Re: Turkey Point Units 3 and 4

Docket Nos. 50-250 and 50-251

Emergency Plan Implementing Procedure Changes

SUMMMARY OF CHANGES

0-EPIP-20133

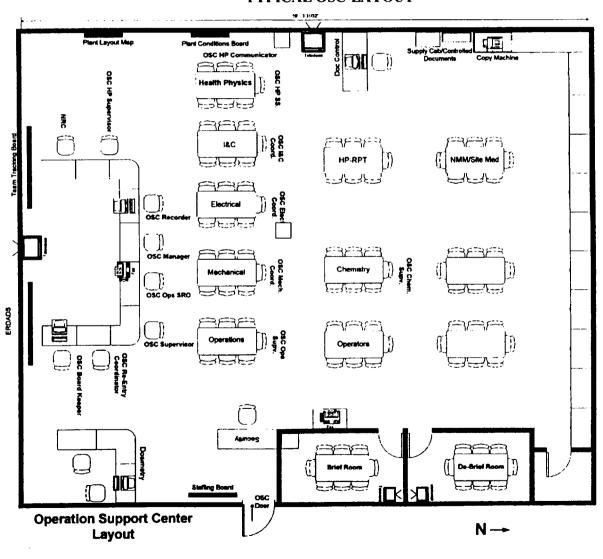
- 1. Move all OSC responder required activities from section 5 to their respective sign-off attachments.
- 2. Add guidance to section 5 for responders to obtain their sign-off attachment.
- 3. Delete the OSC Plant Status Board position, and add those individuals to Status Board Keeper position.
- 4. Delete the OSC Team Status Board position, and add those individuals to Status Board Keeper position.
- 5. Add sign-off section for each OSC responder: Attachments 5 thru 24.
- 6. Change OSC Layout.
